# CITY OF TEMPE DEVELOPMENT REVIEW COMMISSION

Meeting Date: 02/26/2019

Agenda Item: 2

<u>ACTION</u>: Request a Development Plan Review for a new multi-family residential development consisting of 11 two-story condominium units for HUDSON LANE CONDOMINIUMS, located at 55 West Hudson Lane. The applicant is Fine Line Designs. (PL180192)

ARCHITECTURAL SITE PLAN

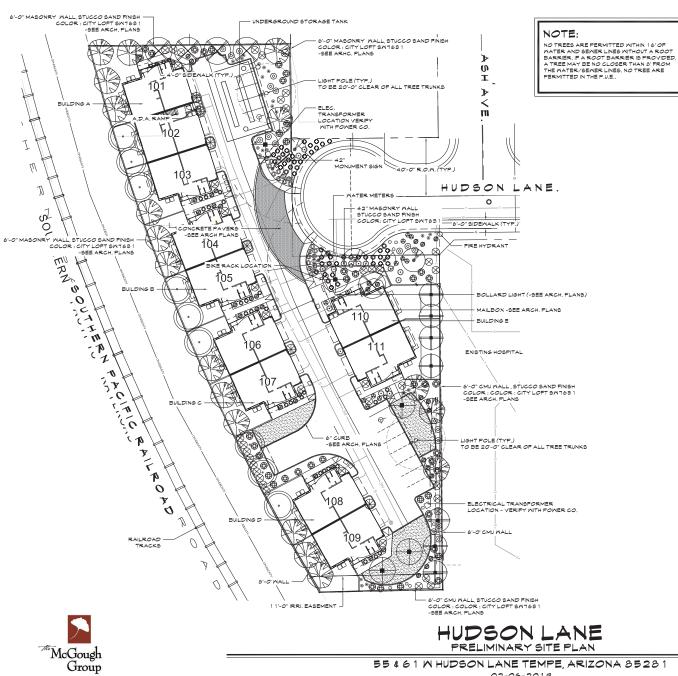
1. Question: Was the front driveway entrance able to have an enhanced accent pavement instead of asphalt.

2. Question: Confirming the amount of parking required for residence and guests.

Answers: Yes per the site plan and Landscape plan the driveway approach to be colored stamped asphalt with the approval of Srini Goundla City of Tempe Transportation Division.

Answers: Total parking required 30 spaces. Total parking provided 34 -four additional spaces than requires. See parking calculation on the Architectural Site Plan.

BUILDING A ELEVATIONS A-7

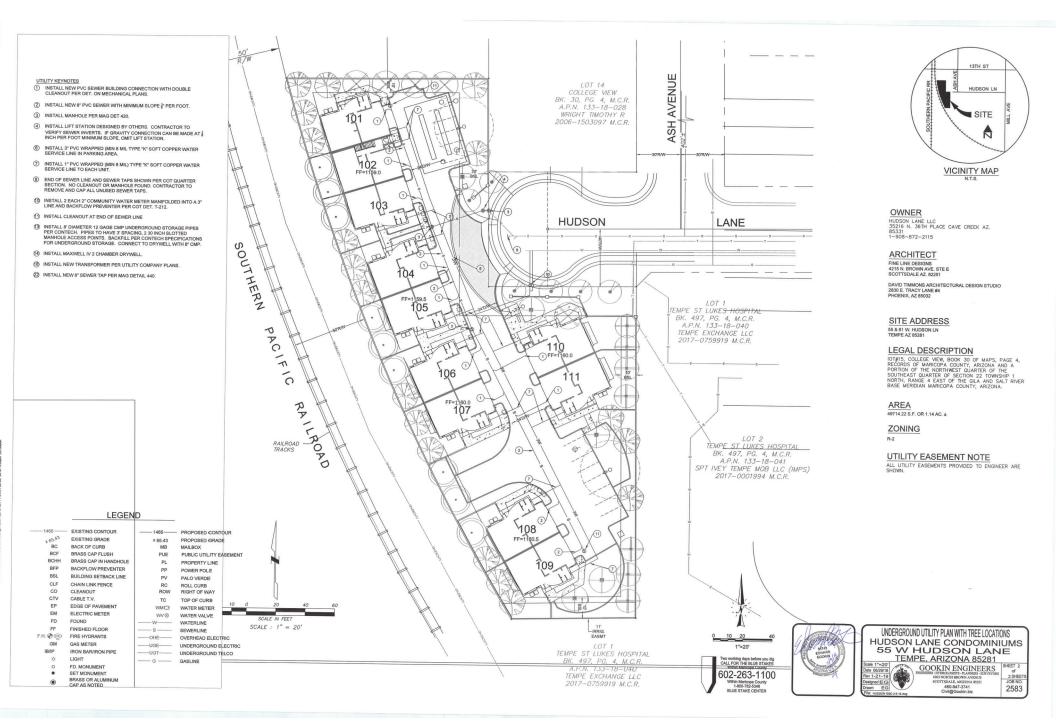
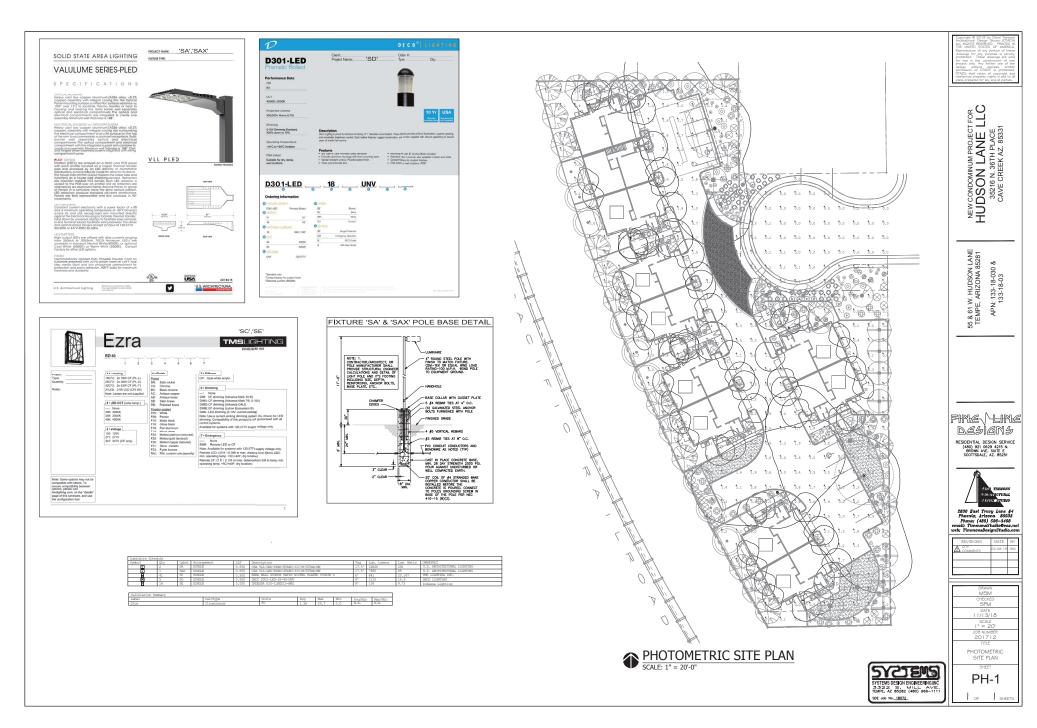
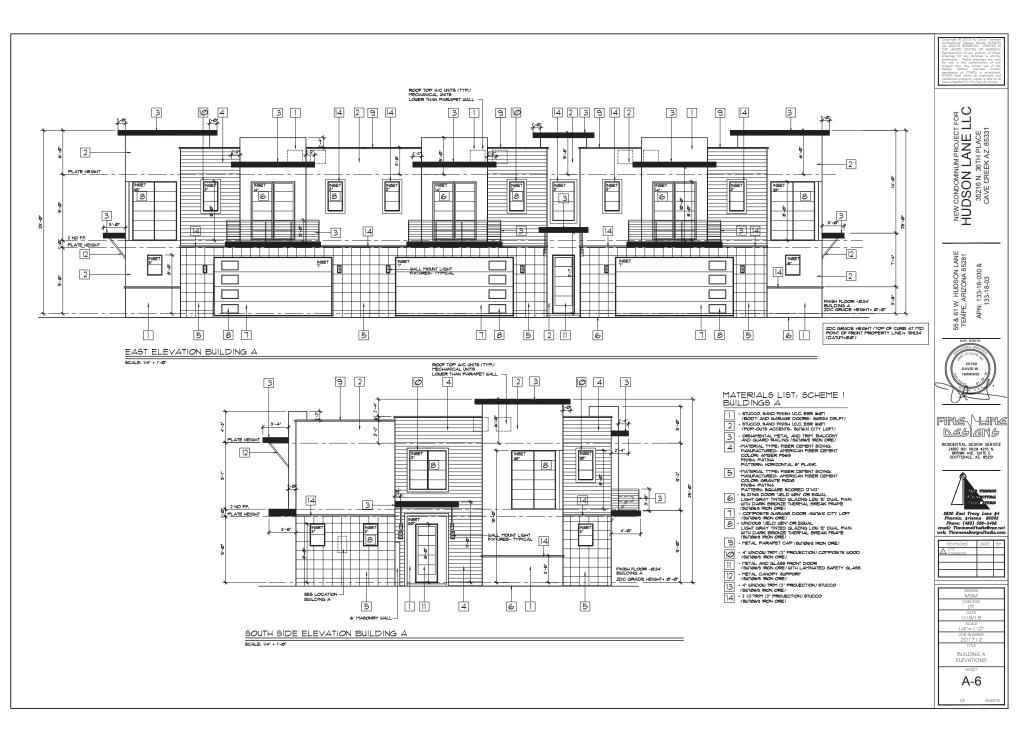
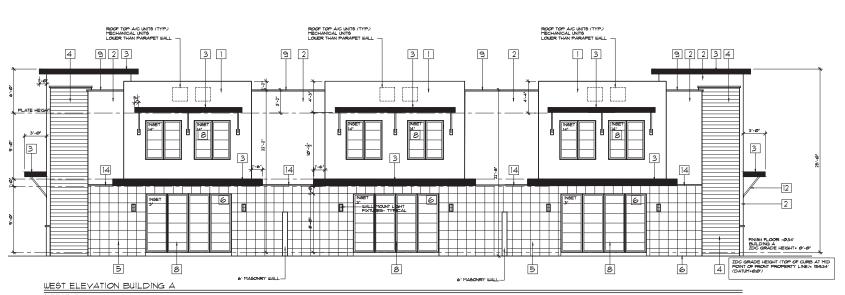
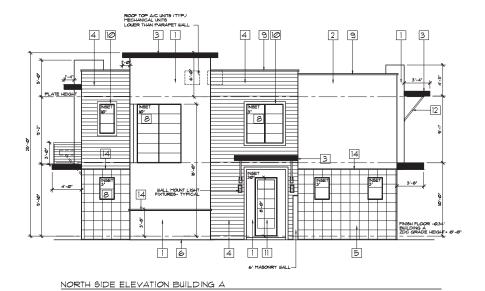
After discussions with the applicant, a stipulation (#7) is included to replace the 12-inch by 12-inch square fiber cement siding with masonry. This modification provides a textural difference for a well-defined base and protects the walls from possible damage caused by vehicles.

- 7. Replace the 12-inch by 12-inch square scored fiber cement siding with integrally colored smooth, ground, scored, or split face masonry.
- 8. If provided, roof access shall be from the interior of the building. Do not expose roof access to public view.
- Conceal roof drainage system within the interior of the building.
- 10. Incorporate lighting, address signs, and incidental equipment attachments (alarm klaxons, security cameras, etc.) where exposed into the design of the building elevations. Exposed conduit, piping, or related materials is not permitted.
- 11. Locate the electrical service entrance section (S.E.S.) on building elevations that do not face the project's main drive aisle.
